TECHNICAL SERVICE BULLETIN

10066

MODEL(S): All versions of the 29LTD

DESCRIPTION: Identifying the audio amplifier

TA7222 vs. YD1022

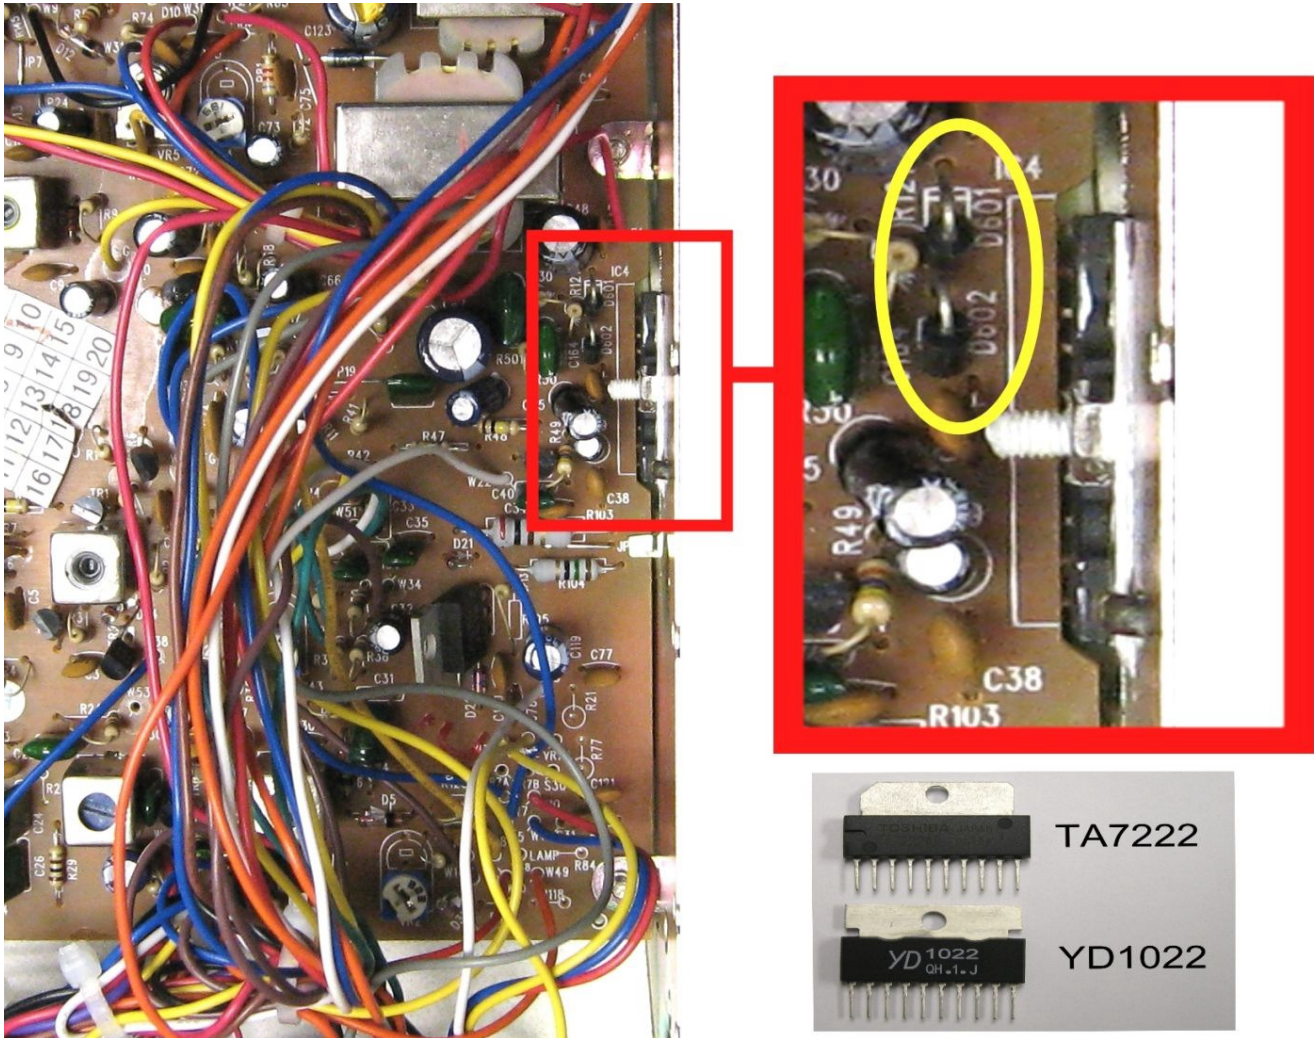
Both of these devices use a 10-pin inline package (SIP) and look very similar. The easiest way to determine which one the radio needs is to check for diodes D601 and D602. If these diodes are present, then the radio uses the YD1022. If the diodes are missing then the radio uses the TA7222. The diodes are located right in front of the audio amplifier as shown below:
